REFERENCE  
**LHC-TC-EC-00XX**

Date: 2017-12-20

## ENGINEERING CHANGE REQUEST

# Upgrade of the crystal collimation test stand in IR7

Figure 1 — 3D view of the horizontal goniometer setup: the crystal can be inserted into the beam only when the C-shape replacement chamber is moved out (on the bottom in the figure). The 3D reference corresponding to the crystal collimator in the horizontal configuration is the ST0563346\_01.

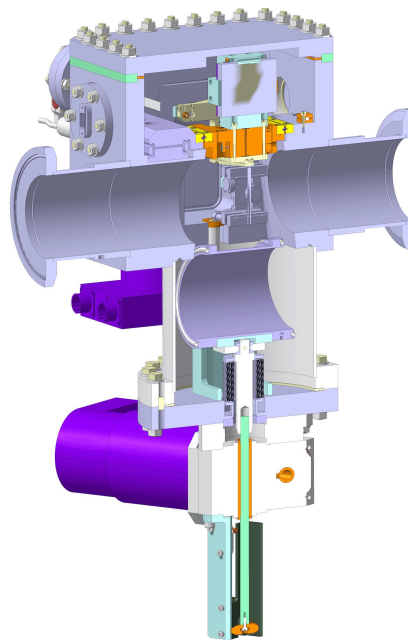
At this stage, we assume that the design of the TCPC assembly remains very similar to the presently installed hardware, see Fig. 1. It relies on a movable replacement chamber that allows inserting the crystal close to the beam only in its “out” position. In standard operation for proton beams, this replacement chamber will be in its “in” position and hide the crystal from the circulating beam.

As a design requirement, possible design modifications from the present hardware must fit into the present installation slots, so that the present assemblies can be replaced with minor changes (as for example it was described in [4]). At this stage, we also assume that no additional controls cabling is required and that the present ones will be used in case new TCPCs are installed.

The detailed description of which one(s) of the 4 TCPC shall be changed in LS2 will follow after the experiments’ results in the LHC, through an update of this document. At this stage, we assume conservatively – for resource estimates – that all the 4 TCPCs shall be replaced.
